1.1.2 The Proposed Development description for the outline planning application, planning reference: 21/01630/OUT, is as follows:

1.1.4 This response has been prepared to address the four reasons for objection raised by OCC in their latest consultation response, as well as to provide additional information relative to highway matters.

# TECHNICAL NOTE: RESPONSE TO OCC COMMENTS

Figure 3-1: Proposed Mini-roundabout General Arrangement

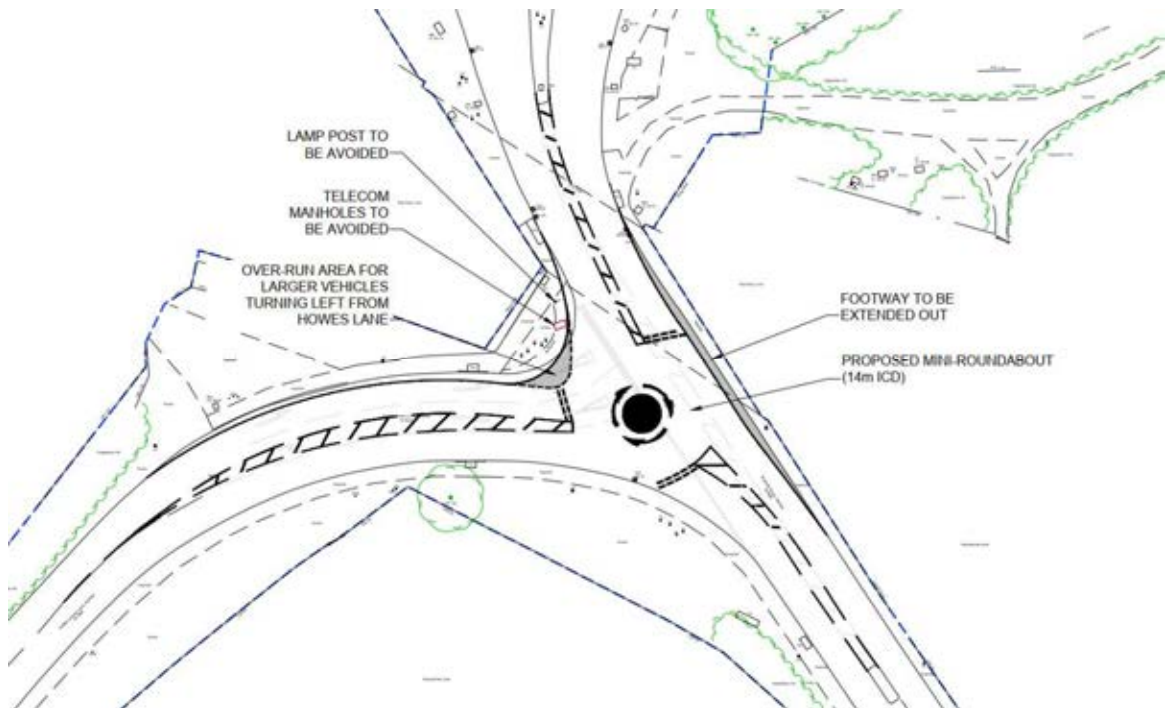
- 3.1.1 To mitigate the impact of the traffic associated with the 530 dwellings of the Proposed Development at the junction and improve the operation of the existing A4095 Howes Lane / Bucknell Road priority junction, a mitigation scheme in the form of a proposed mini-roundabout arrangement has been developed.
- 3.1.2 The proposed mini-roundabout design has been developed in accordance with the requirements of the Design Manual for Roads and Bridges (DMRB) CD 116 Revision 2 'Geometric Design of Roundabouts'.
- 3.1.3 A plan showing the proposed arrangement of the mini-roundabout is included at **ATTACHMENT E**, and an extract of the General Arrangement is presented below in **Figure 3-1**.

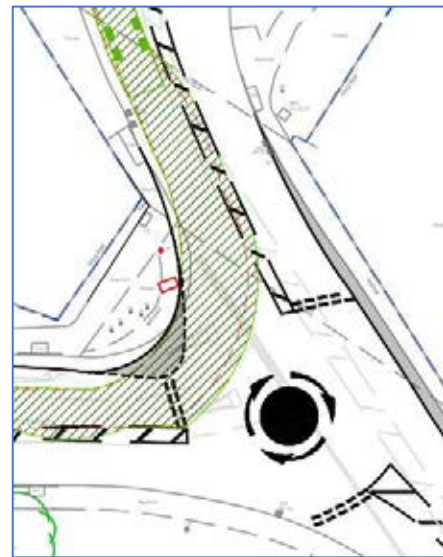
Summary: Late braking or failure to give way type collisions

On the northern, Bucknell Road entry, drivers may fail to appreciate the presence of the mini roundabout, as siting of the diag 611.1 sign may be problematic and there may be reduced forward visibility to the sign. Poor perception of the change junction arrangements may lead to failure to give way or late braking shunt type collisions.

**Recommendation:**

It is recommended that forward visibility to the diag 611.1 sign is maximised to provide adequate warning of the junction type. Existing map type direction signs for the conventional roundabout on the A4095 (E) and Bucknell Road (N) approaches should be amended to clearly identify the new roundabout junction at Howes Lane.

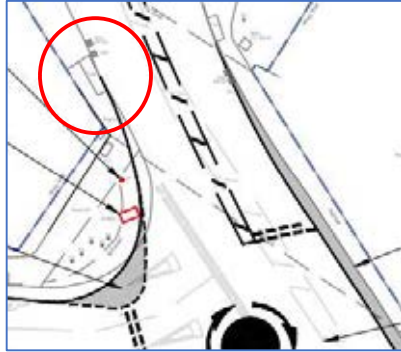
Whilst on site, the audit team noted that the drivers of large vehicles over-ran the central hatched area and opposing traffic lane when making a left turn manoeuvre from Howes Lane on to Bucknell Road. The swept path drawings provided indicate that drivers of large vehicles may have to carry out a precise left turn manoeuvre to avoid over-running the opposing traffic lane or striking nearside kerbs. This manoeuvre may lead to vehicle to vehicle collisions with the introduction of the mini roundabout and revised kerb line of the eastern side of Bucknell Road.

**Recommendation:**

It is recommended that measures should be introduced to minimise the likelihood of large vehicle swept paths crossing the hatched areas and entering the opposing traffic lane; measures may include widening the hatched markings separating the two traffic streams, reducing the southbound traffic lane width, and amending the eastern kerb line.

FOOTBRIDGE INFORMATION

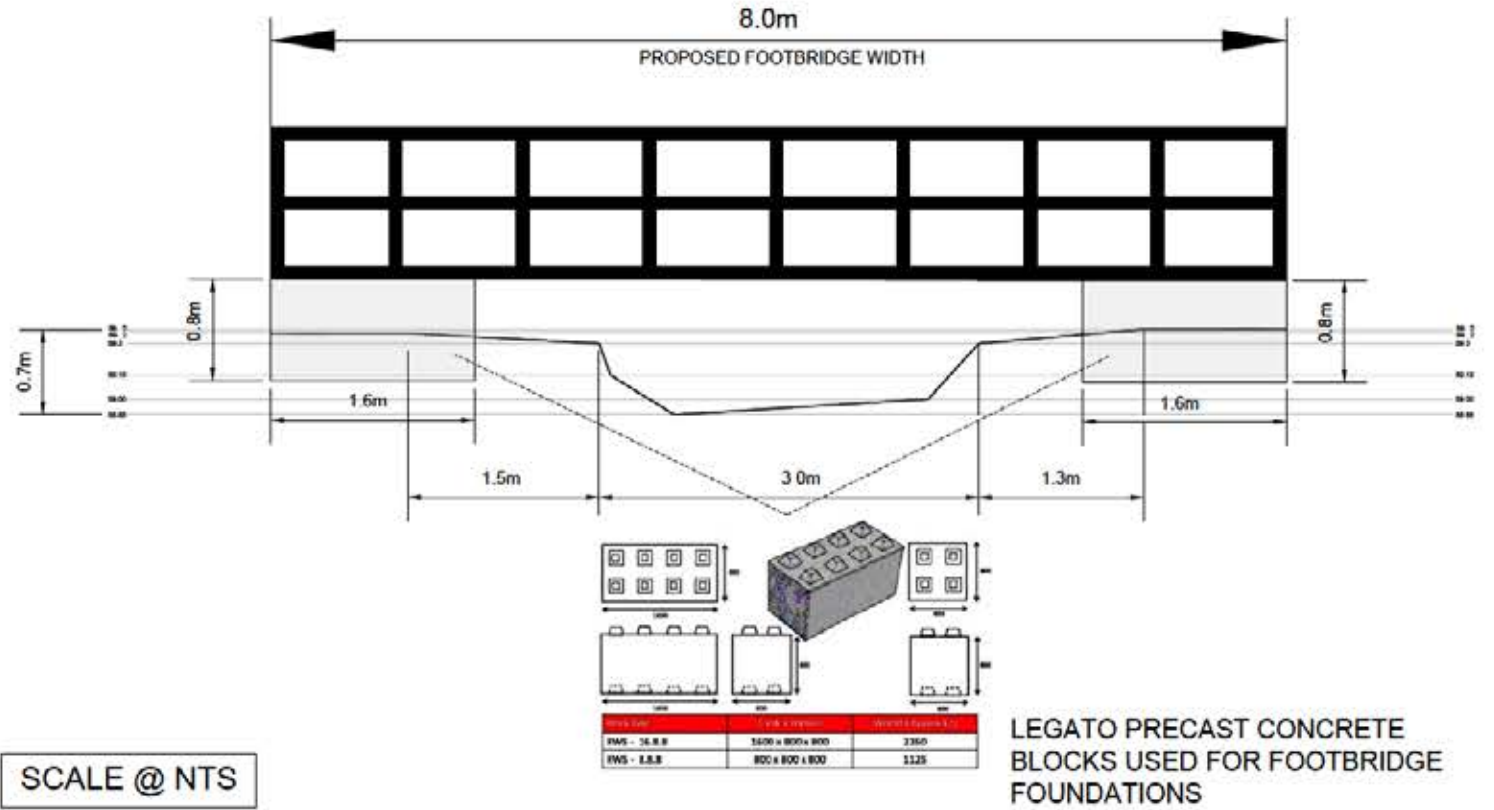
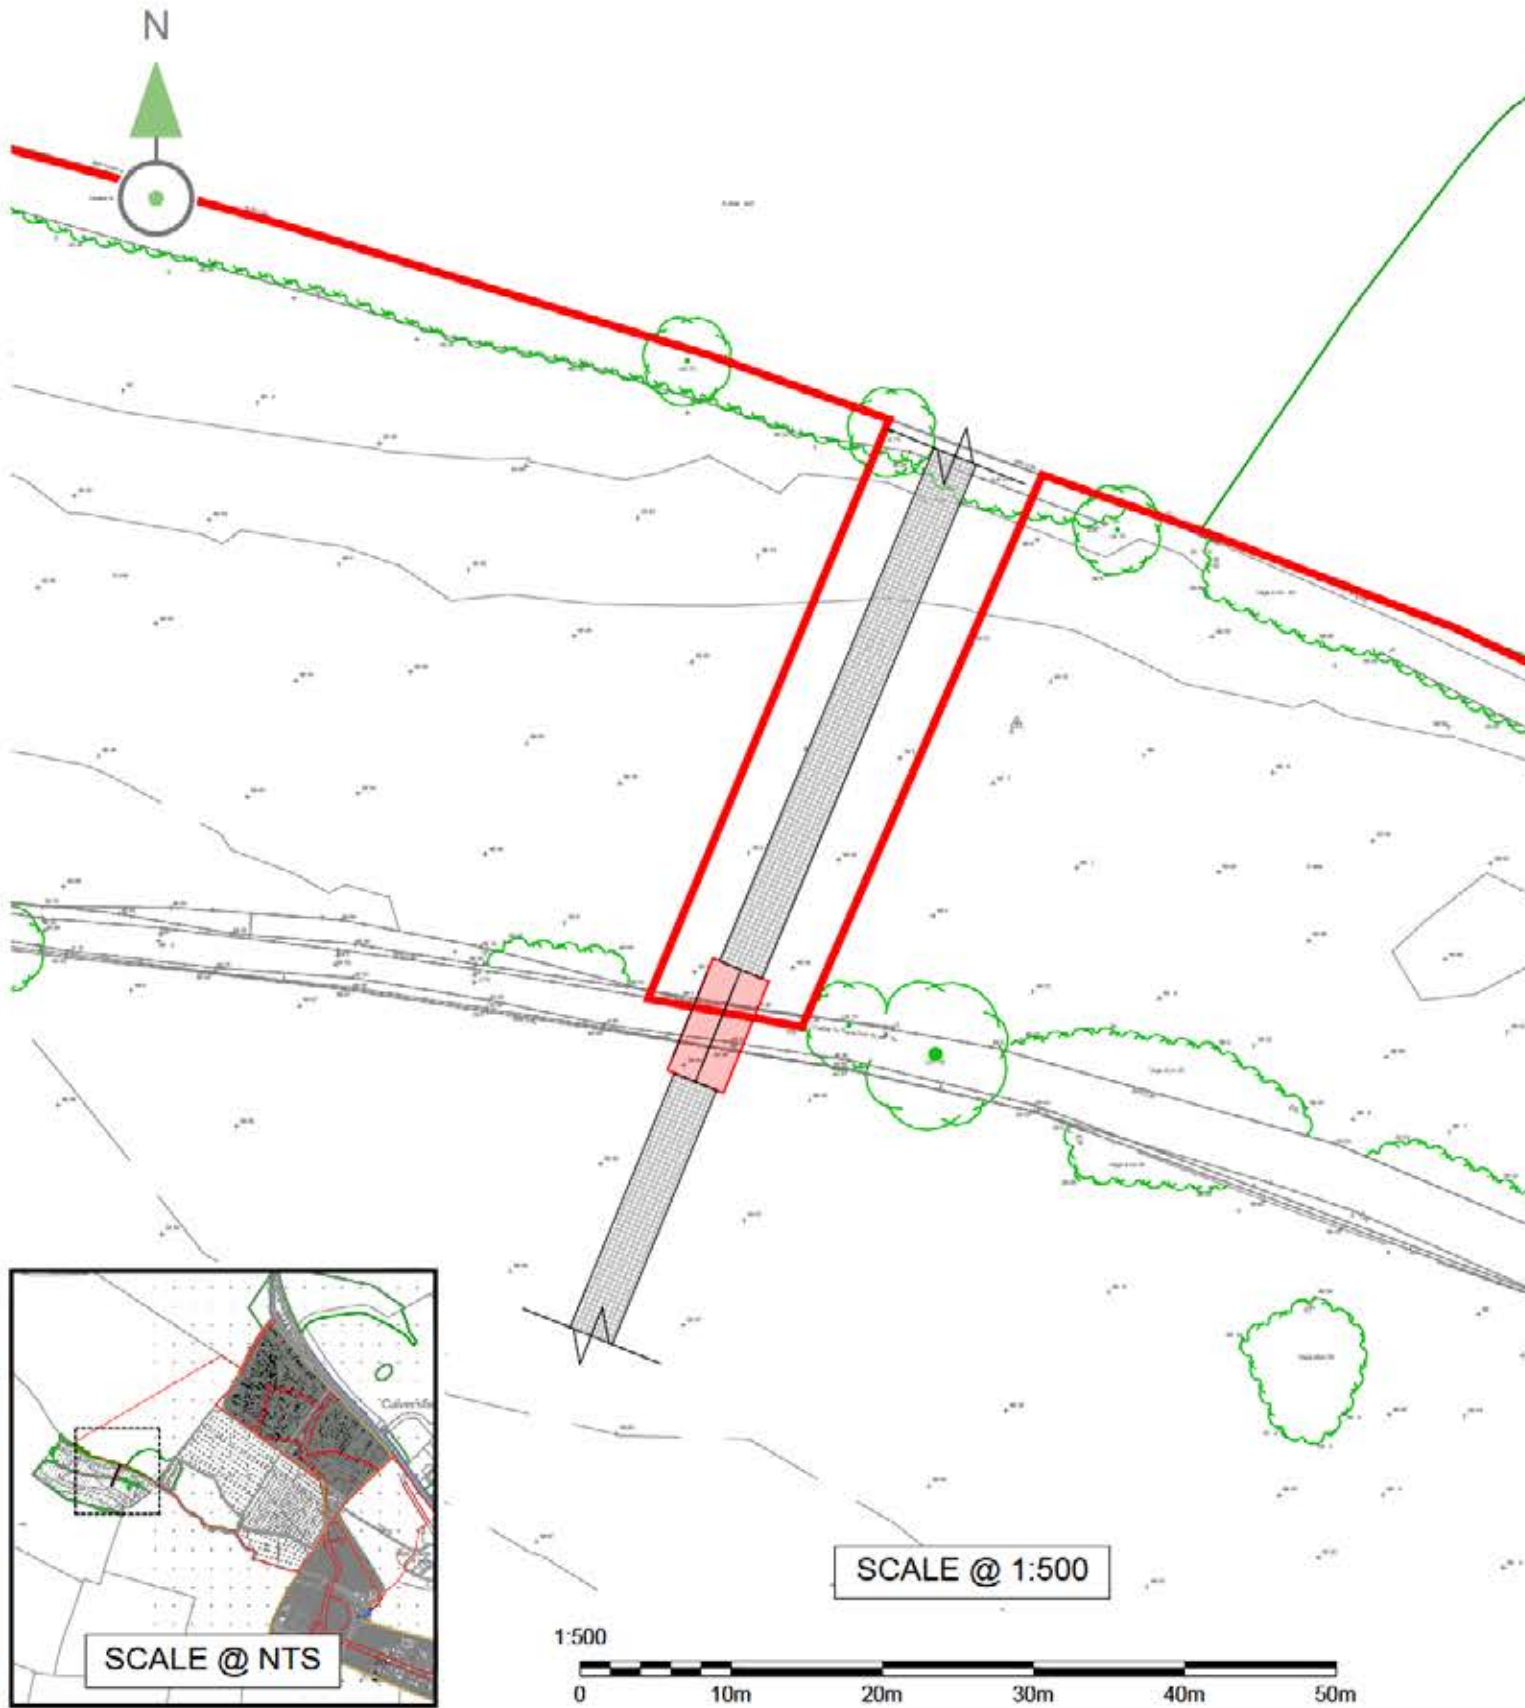
- 2.5.3 Item 11 of the “Detailed Comments” provided by OCC in the response dated the 05<sup>th</sup> of January 2022 noted that a contribution towards the proposed ped/cycle connection to the nearby Hallam Land development via a footbridge over the watercourse to the south of the western parcel, is accepted. However, OCC has requested that further details be provided for this proposed footbridge, including the location and a cost associated with this footbridge in order that a financial contribution (25%) can be identified within the associated Section 106 Agreement should the application be granted planning permission.

- 2.5.4 Based on this request for further details of the footbridge, a topographical survey of the watercourse was commissioned and VTP Drawing 4600-1100-T-059 Rev A has been prepared to show the proposed layout, cross-section, and details of how this footbridge could be delivered.

- 2.5.5 The design of this footbridge is identified as being in the order of 8.0m in length to cross the identified watercourse and 4.0m in width, to accommodate both pedestrians and cyclists. Beaver Bridges has been contacted to provide details of a potential footbridge and have included a cost estimate by email dated the 22<sup>nd</sup> of March 2022 for the installation of this footbridge. This cost estimate would be subject to further considerations as details of the ground conditions, the cost of materials, and labour would still need to be clarified at the detailed design stage. However, a review of the costs provided within the email quotation could be considered to be robust at a total cost of £70,000 + VAT. Based on a 25% contribution that would be considered reasonable to be committed to by the Applicant, a Section 106 Contribution of £17,500 would be required.

- 2.5.6 The full details of the VTP Drawing, the Beaver Bridge brochure for a polybridge, and the cost estimate dated the 22<sup>nd</sup> of March 2022, are included at **ATTACHMENT D**.
